[Docket No. FAA-2010-1101; Directorate Identifier 2009-CE-013-AD; Amendment 39-16690; AD 2011-10-09]

Airworthiness Directives; Cessna Aircraft Company Models 150, 152, 170, 172, 175, 177, 180, 182, 185, 188, 190, 195, 206, 207, 210, T303, 336, and 337 Airplanes

ACTION: Final rule.

Figure 1. Diameter of seat pin locking engagement hole

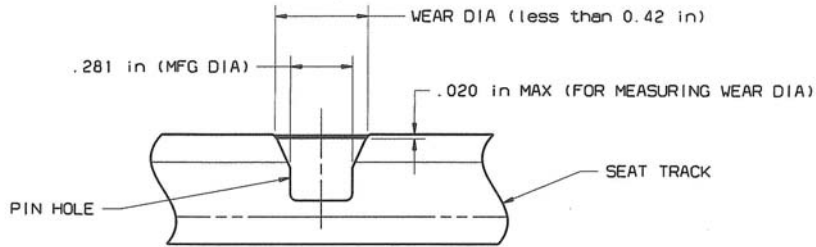
Dave McFarlane requested we add a maximum allowable incremental 0.07-inch radius dimension to figure 1 at the outside diameter dimensions for clarification.

We disagree with this comment. The measurement dimensions in figure 1 adequately address the measurements necessary for this AD. Additional measurements will not provide any additional benefit.

Figure 4. Closeup of seat roller housing and tang gap width

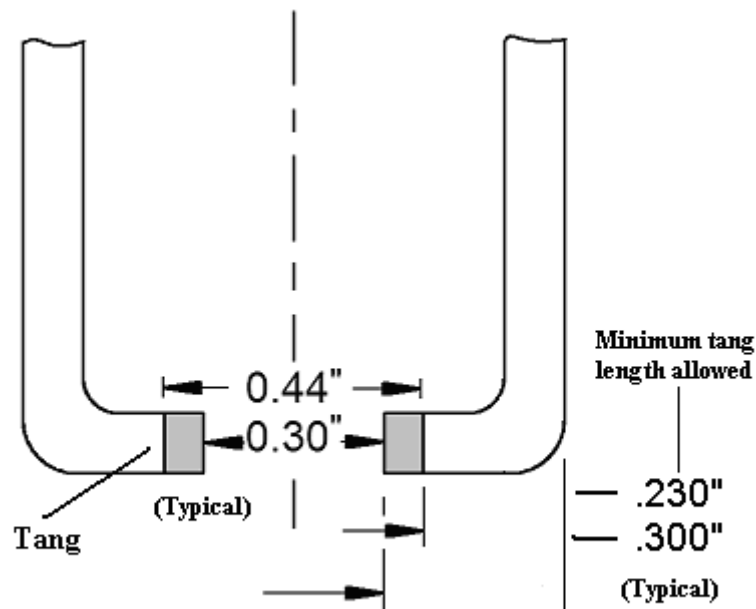
Brian A. Andrus, Jim Currie, and Jerry Unruh requested we change the tang measurement to the outside of the seat roller housing and change the description of the tang measurement. This change would make it easier for the inspector to take the measurement and to better understand what is being measured.

We agree with this comment. We agree that measuring the tang length inside of the roller housing is difficult because of the presence of the rollers inside of the roller housing.

We have changed the callouts in figure 4 to measure the tang length from outside of the roller housing instead of from inside of the roller housing. We have also changed the description of the tang measurement in figure 4 to more accurately describe the measurement.
